UNITED STATES PATENT AND TRADEMARK OFFICE  
**CERTIFICATE OF CORRECTION**

PATENT NO. : 6,967,424 B2  
APPLICATION NO. : 10/758109  
DATED : November 22, 2005  
INVENTOR(S) : Vladimir Vladimirovich Popov

Fig. 2a

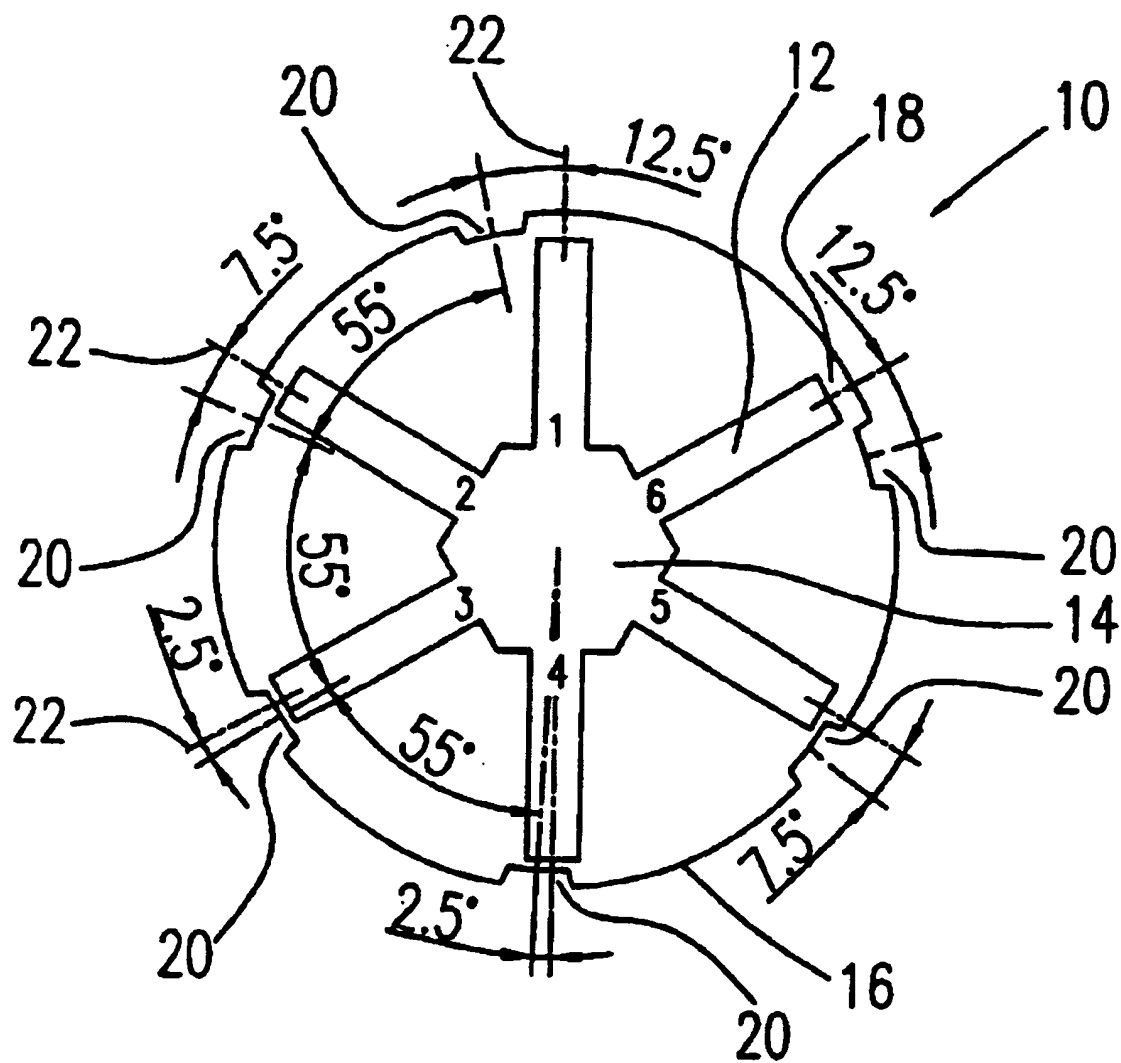
in Figure 2a show groove 200 to be in the same tangential position with regard to the slots of laminations 10-1, 10-2, 10-3, 10-4, 10-5 and 10-6. A corrected Figure 2a is shown on attachment page 3 of 3; and

Fig. 2b

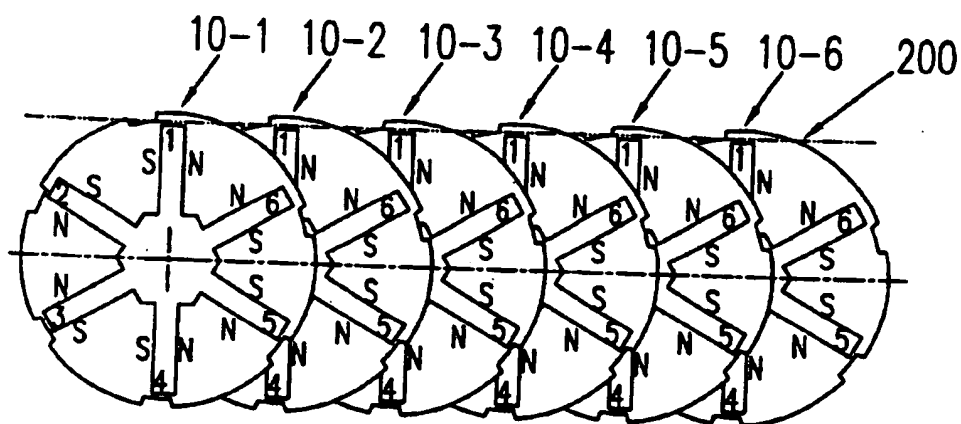
in Figure 2b show groove 201 to be in the same tangential position with regard to the slots of laminations 10-1, 10-2, 10-3, 10-4, 10-5 and 10-6. A corrected Figure 2b is shown on attachment page 3 of 3.
